Board of Zoning and Planning

Staff Report

September 28, 2023

Site Plan view from the north

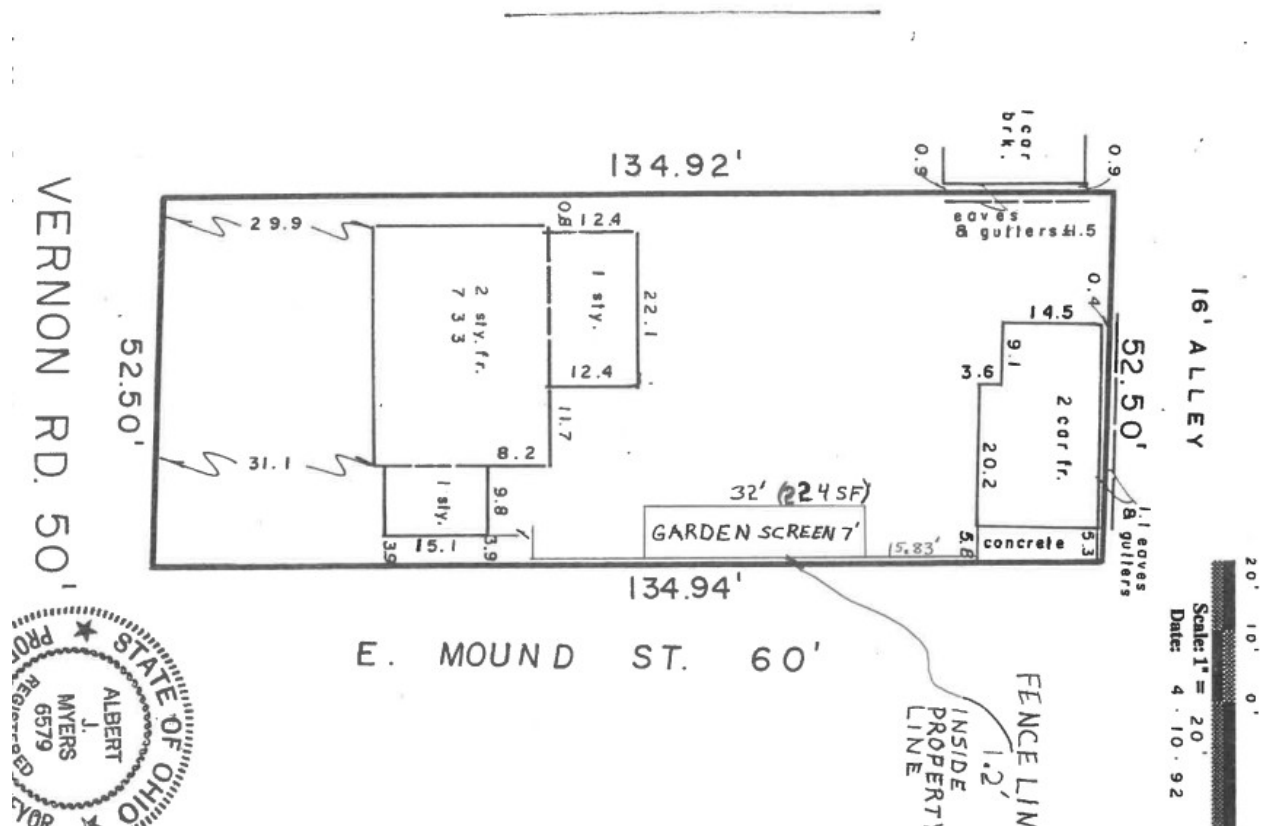
The structure in question was installed without benefit of a review application or building permit. The fact that this is also a little unusual in design and is being called a Garden Screen; makes it questionable as to how it should be classified. The structure is 7' tall at the eave, 8' tall at the ridge, 7' wide and 32' in length. It is constructed 1.2' inside and parallel to the north property line along Mound Street.

A structure such as a fence is limited to 48" in height along a street side property line. A new 42" high fence replaced the previous 42" high fence. The garden screen is attached to the new 42" fence.

If it does receive a variance, will it need to be landscaped along the right-of-way?

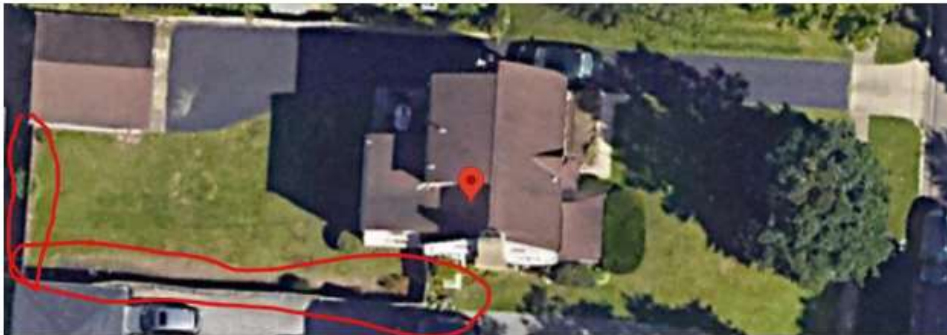
On July 19, 2023, I was out making inspections and discovered the fence and thought it looked over 72" in height. I stopped and measured the fence which was 87" high, along the alley and could see that it continued along the south side property line. When I checked for a fence permit, I found that on May 19, 2023, Fence Application F-23-65 was submitted with a request to replace the existing 6' fence with a new 6' fence and approved on May 22, 2023.

The owner purchased the property in December 2022. Due to concerned about being able to see the neighbors, he decided to replace the fence with the current fence that is a standard 72" tall panel with an additional 15" framed lattice above.

The 72" high limit for a fence is pretty standard. The additional height of the fence is lattice, which still allows you to see through. If a variance is approved by the Board, this could be the

first of many more fence variance requests to come. Landscaping is always an option that could be consider by the applicant to obtain the screening they find necessary. I am not inclined to support this variance request.

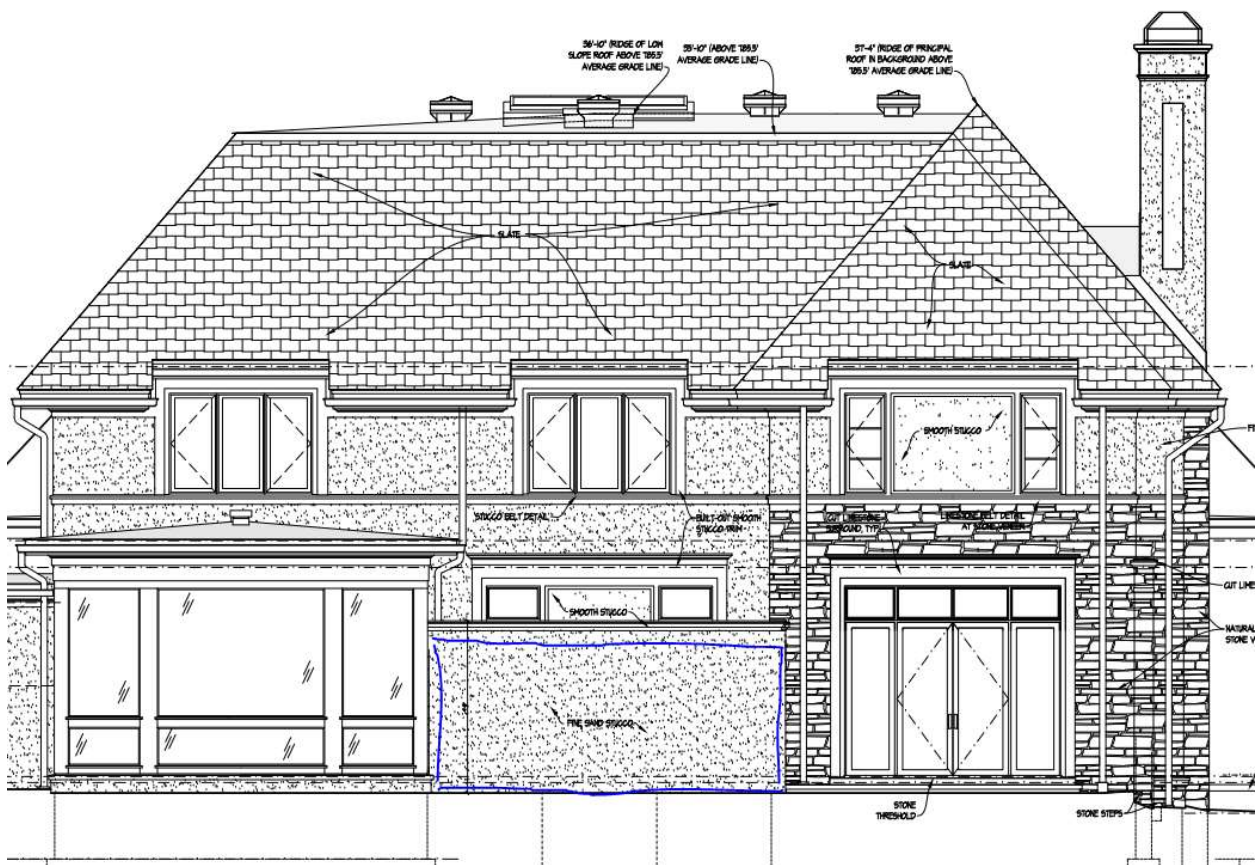
The therapeutic bath is proposed on the north side of the principal structure, but would be built into the terrace off of the master bath, and within an enclosed courtyard.

The bath could be considered a "pool" being it's deeper than 18" and a pool is an accessory structure, which is limited to the rear yard. The minimum setback required for a pool is 8'.

The fact that the courtyard did not have a roof, I decided to err on the side of caution and have the Board confirm what I find to be acceptable due to the fact that it is proposed within an enclosed space that is inside the building setback lines, on what was originally an open terrace. The proposed wall of the courtyard would be located 12' from the north side property line and a continuation of the wall of the principal structure.

The courtyard therapeutic bath, as presented, should have a low impact on the neighboring property and is screened by a wall, proposed landscaping, and existing trees and shrubs that will also remain between the courtyard and the north property line.

I do not see a concern, but simply want to allow the Board to confirm my findings, that it may not technically be “in the side yard” when it is within the building setback lines and walls of the principal structure.
